# HISTORIC AND DESIGN REVIEW COMMISSION

December 06, 2023

**HDRC CASE NO:** 2023-458  
**ADDRESS:** 110 LEXINGTON AVE  
**LEGAL DESCRIPTION:** NCB: 804 BLK: 32 LOT: W IRR 69.22 OF A9 & W IRR 96.14 OF A10  
**ZONING:** FBZ T6-2, H, RIO-2  
**CITY COUNCIL DIST.:** 1  
**APPLICANT:** Ellis Mumford-Russell/Post Oak Preservation Solutions  
**OWNER:** Kelly Sinclair/EL TROPICANO HOTEL LLC  
**TYPE OF WORK:** Construction of a patio within the right of way, construction of a stair to connect the River Walk path with Lexington Avenue, rooftop/pool level modifications  
**APPLICATION RECEIVED:** November 15, 2023  
**60-DAY REVIEW:** January 14, 2024  
**CASE MANAGER:** Edward Hall

## REQUEST:

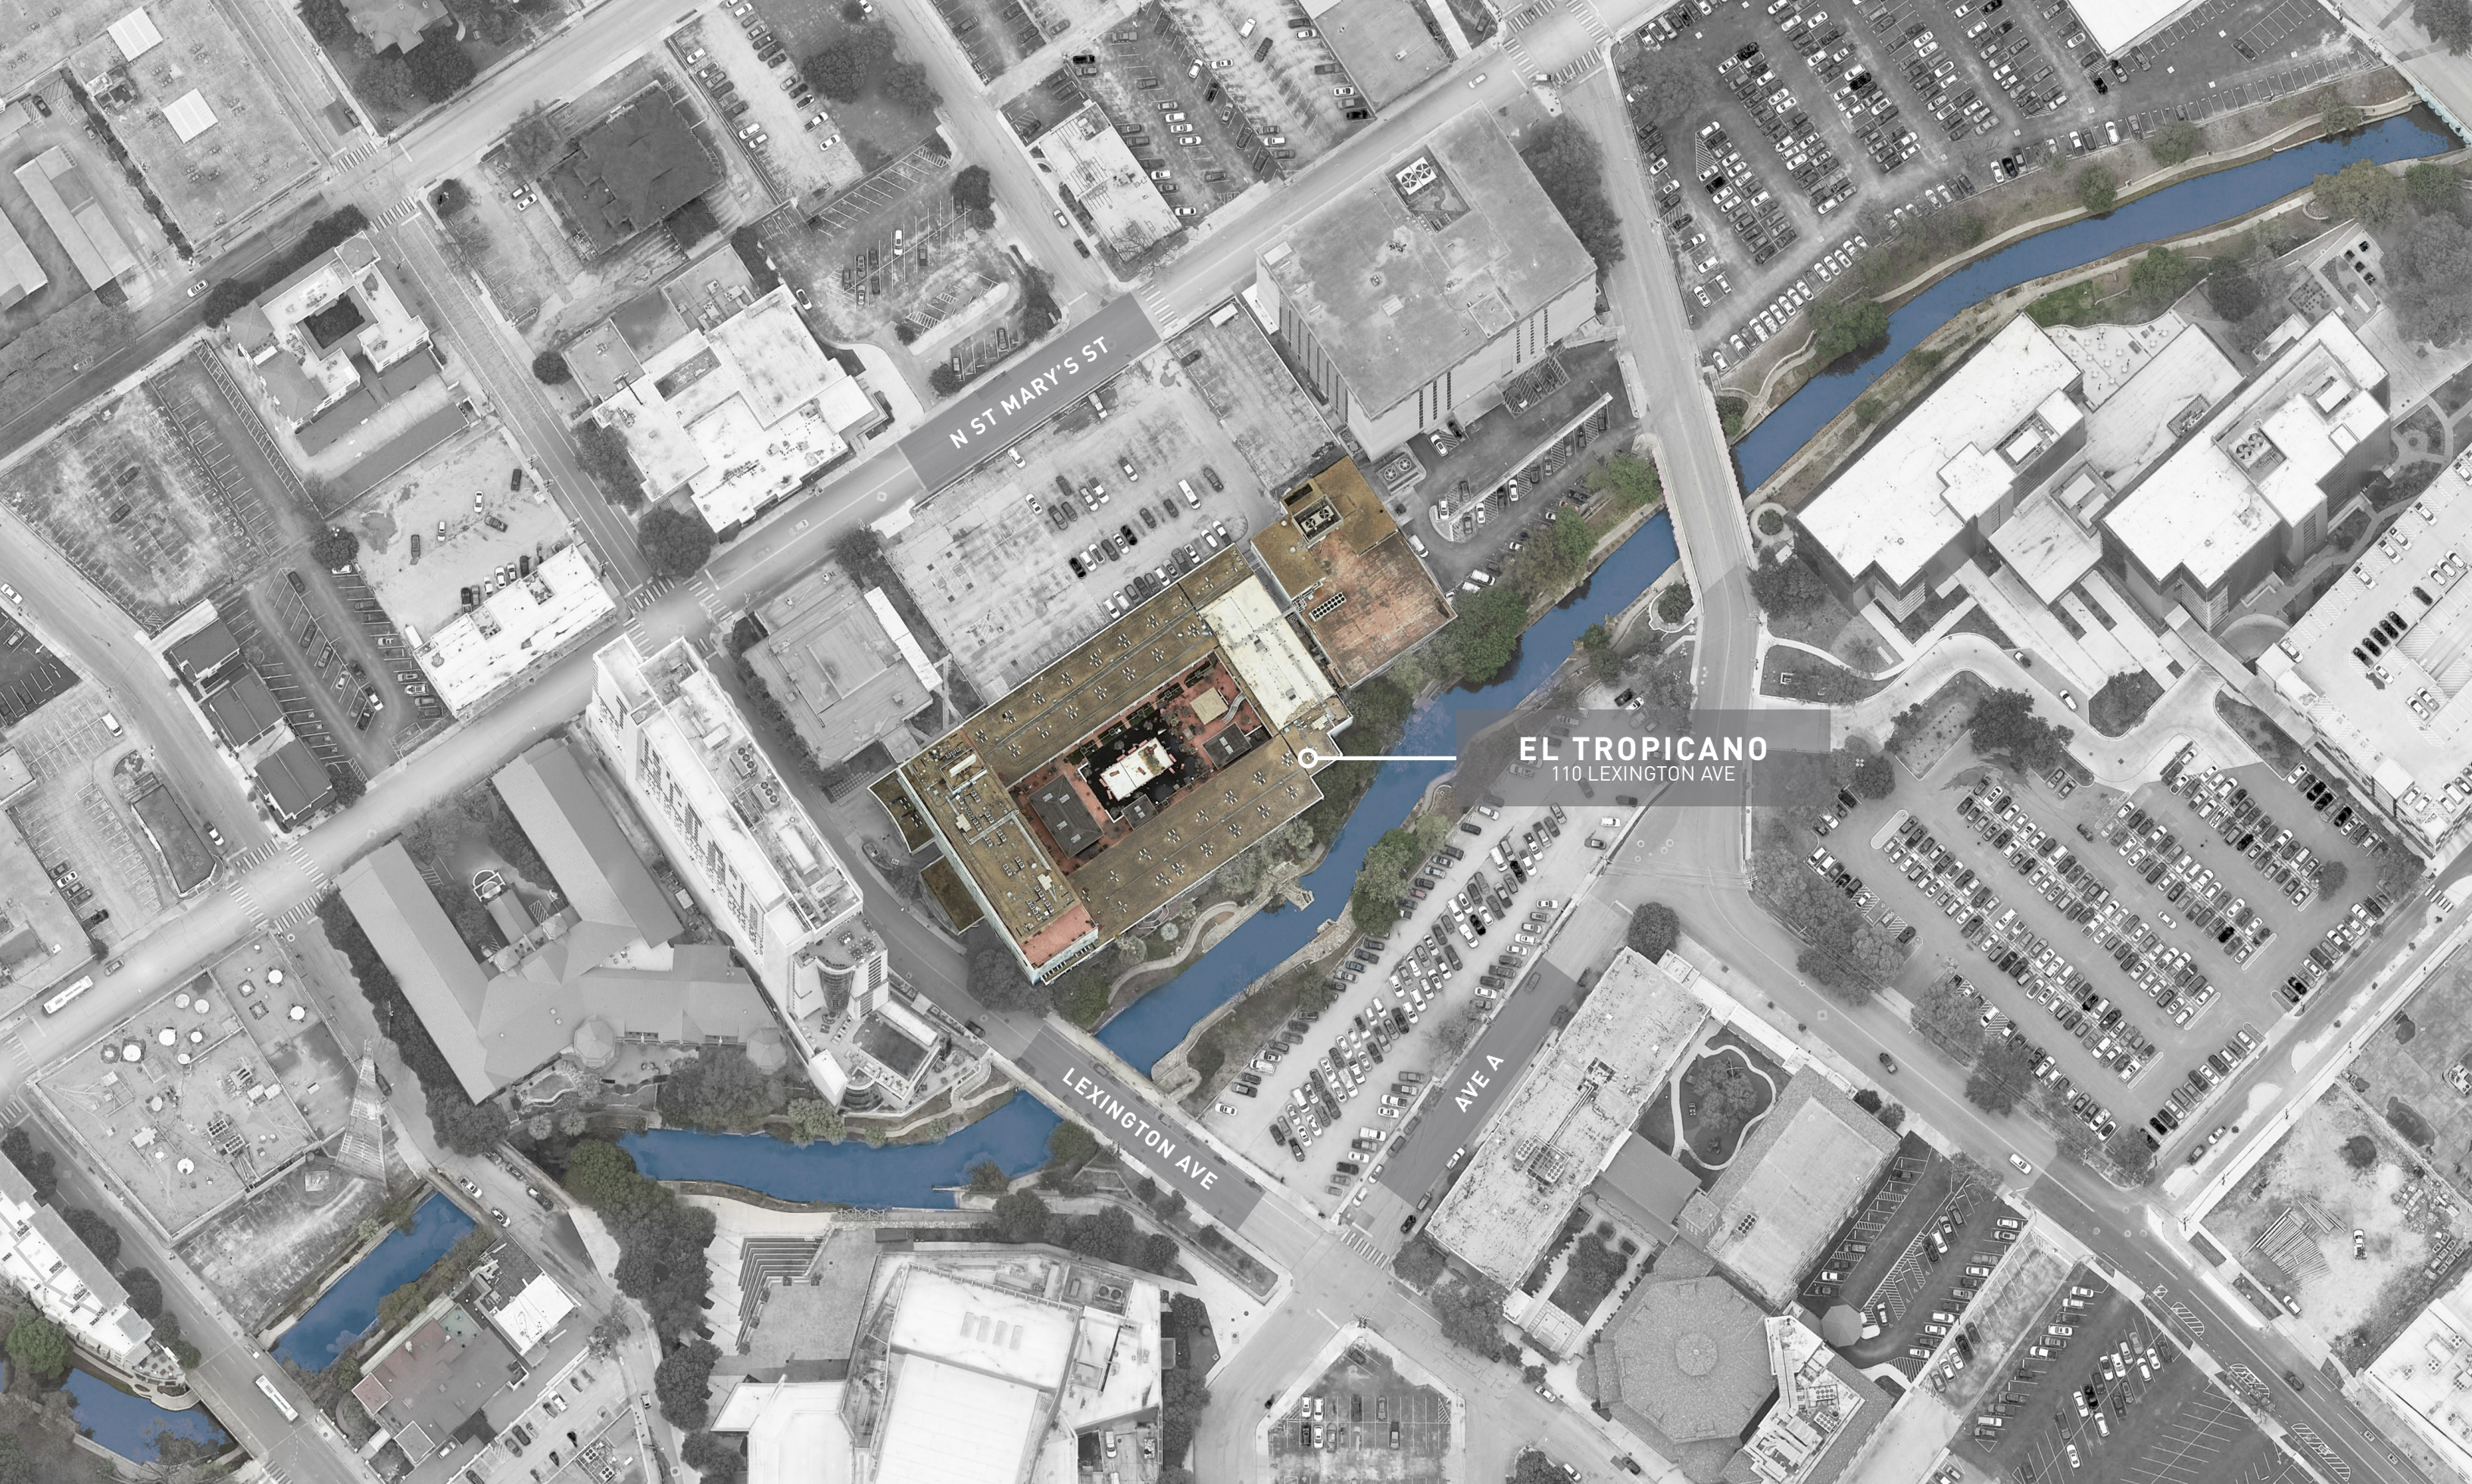
- f. PATIO/DECK – The applicant has proposed to construct a riverside patio with a deck element that will extend over the publicly owned right of way. The proposed patio and deck will begin to the immediate east of the Lexington Avenue bridge and will extend to the east, parallel with the building's façade. The proposed patio and deck will feature a total size of 4,922 square feet, with 1,302 square feet extending over the property line into the right of way. Generally, staff finds the proposed patio and deck to be appropriate. The applicant is responsible for coordination with both the San Antonio River Authority regarding direct access to the San Antonio River, landscaping and maintenance boundaries and storm water control measures, as noted in finding e, and the City's Center City Development and Operations Department regarding leasing agreements.

- g. PATIO/DECK – Per the submitted application documents, the applicant has proposed for the patio/deck element to feature both a design and materials that are complementary of the architecture of the original structure as well as the existing design of the pedestrian pathway at the river level. Staff finds that all future design elements should be complementary of existing elements of the historic structure and the Museum Reach.

- h. STAIR CONNECTION – The applicant has proposed to construct a new staircase to connect the River Walk path with Lexington Avenue. The stair connection is to feature a curves profile and be constructed within the public right of way. The proposed connection is permitted per the UDC Section 35-673(o). Staff finds that all design elements, including materials, should be complementary to those found historically on site and along the Museum Reach.

1. Staff recommends approval of item #1, the construction of a patio/deck on the river side of the property to extend within the public right of way based on findings e through g with the following stipulations:

- i. That the applicant coordinate with both the San Antonio River Authority regarding direct access to the San Antonio River, landscaping and maintenance boundaries and storm water control measures, as noted in finding e, and the City's Center City Development and Operations Department regarding leasing agreements.

- ii. That all future design elements should be complementary of existing elements of the historic structure and the Museum Reach.
  - iii. That both a complete construction document set and a landscape document set be submitted for review and approval by the Historic and Design Review Commission.

2. Staff recommends approval of item #2, the construction of a stair connection, based on finding h with the following stipulations:
  - i. That the applicant coordinate with both the San Antonio River Authority regarding direct access to the San Antonio River, landscaping and maintenance boundaries and storm water control measures, as noted in finding e, and the City's Center City Development and Operations Department regarding leasing agreements.
